Access Compliance Report

Public Rights-of-Way

(Curb Ramps)

Intersection ID: 3977	Main Street: FOUNTAINGROVE_DR	Cross Street: GALLOWAY_RD	Location:	E
ADA ID: 6A6ED23ACB38	Ramp Type: PerpDiag	Initial Pass/Fail: Fail	Overall Compliance: No	Severity Score: 47.5
Codes/Mitigation Info/Possible Solution		Field Measurements/Component Compliance

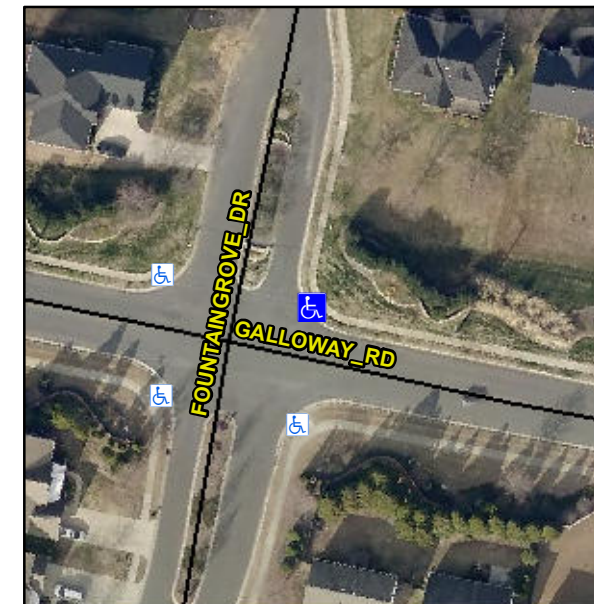
Not Found, R304.5.1, R304.2.2

Compliance	Description	Data	Compliance	Description	Data
N/A	Ramp Length (in)	42.0	No	Ramp Slope (%)	9.8
No	Ramp Width (in)	30.0	Yes	Ramp XSlope (%)	1.7
N/A	Flare Type LT	N/A	N/A	Flare Type RT	N/A
N/A	Flare Slope LT (%)	N/A	N/A	Flare Slope RT (%)	N/A
N/A	Flare Traversable LT?	N/A	N/A	Flare Traversable RT?	N/A
N/A	Landing Length (in)	N/A	N/A	DWS Provided?	N/A
N/A	Landing Width (in)	N/A	N/A	DWS Contrast?	N/A
N/A	Landing Slope (%)	N/A	N/A	DWS Length (in)	N/A
N/A	Landing X Slope (%)	N/A	N/A	DWS Full Width?	N/A
N/A	Landing Curb? (Y/N)	N/A	N/A	DWS Offset (in)	N/A
N/A	Shared Landing?	N/A			
N/A	Gutter Ponding?	N/A	N/A	Gutter Slope (%)	N/A
N/A	Gutter Lip Ht (in)	N/A	N/A	Gutter X Slope (%)	N/A
N/A	Painted X Walk1?	No	N/A	Painted X Walk2?	No
	X Walk 1 Direction	To NW		X Walk 2 Direction	To SW
N/A	X Walk 1 Width (in)	N/A	N/A	X Walk 2 Width (in)	N/A
	X Walk 1 Slope (%)	5.0		X Walk 2 Slope (%)	3.2
	X Walk 1 X Slope (%)	1.1		X Walk 2 X Slope (%)	3.6

Remove & Replace Curb Ramp With Two New Directional Ramps or Equivalent.
